APPLICATION FOR AMENDMENT TO PERMIT

Location 130 Taft Ave Within Fire Limits? Dist. No. Owner's name and address Neak, Sun Telephone Lessee's name and address Telephone Contractor's name and address Petit Landscaping 61 Harding St Bideford, ME 04005 Telephone 282-9305 Architect Plans filed No. of sheets Proposed use of building 1-fam No. families Last use 1-fam No. families Increased cost of work -0- Additional fee 25.00

REASON FOR PERMIT: enclose existing Deck

RE: 130 Taft Avenue - R-3 zone - 273-A-14 to 16

CHECK-LIST AGAINST ZONING ORDINANCE

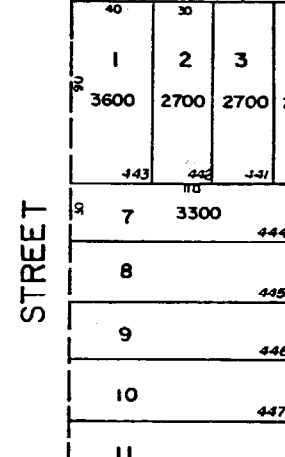
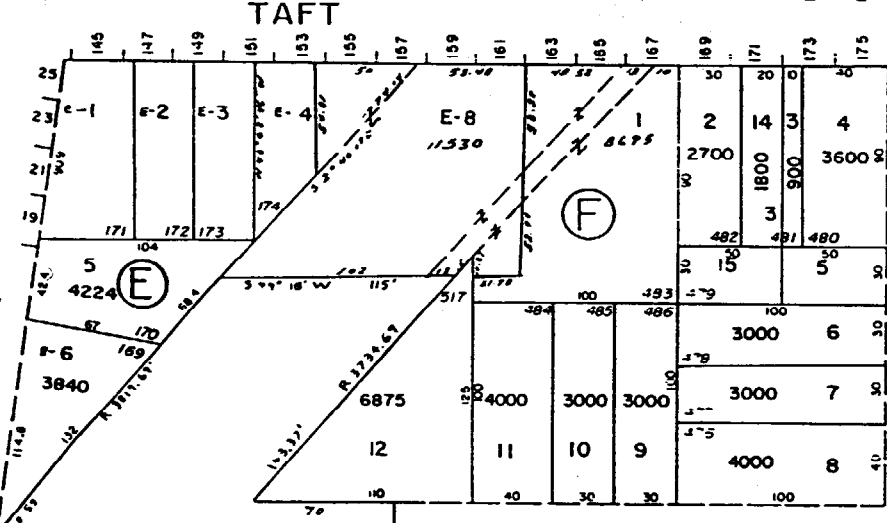
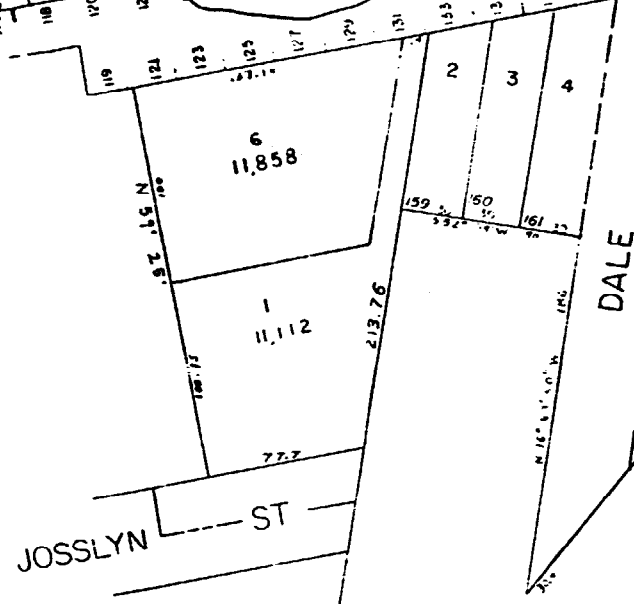
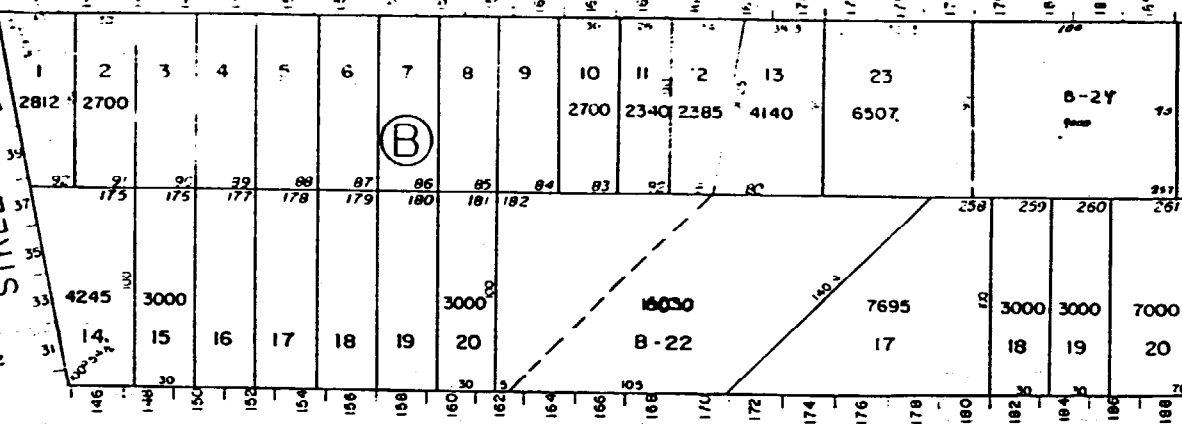
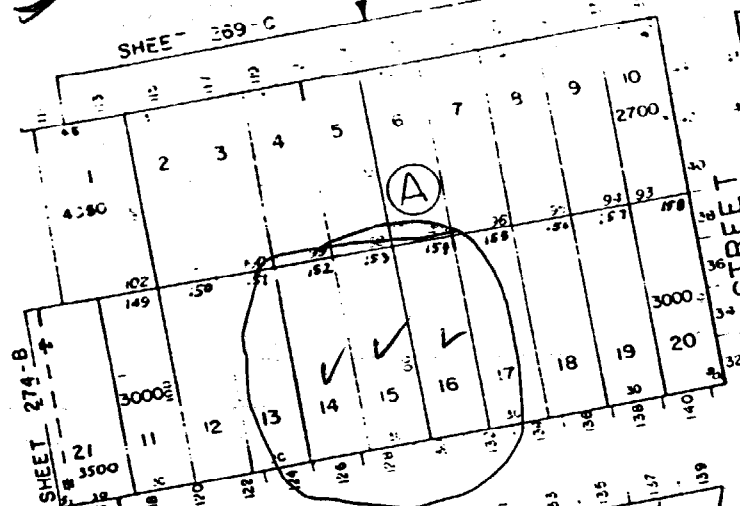
Front Yard - ~~25'~~ 25' req? 27' shown

Rear Yard - 25' req - 35' shown

Side Yard - 14' req - 23' 6" shown -

Projections - 2nd floor projects into the front yard 1 foot (ok)
per given setbacks

Lot Coverage/ Impervious Surface - 25% of lot area = 2250^{sq} ft
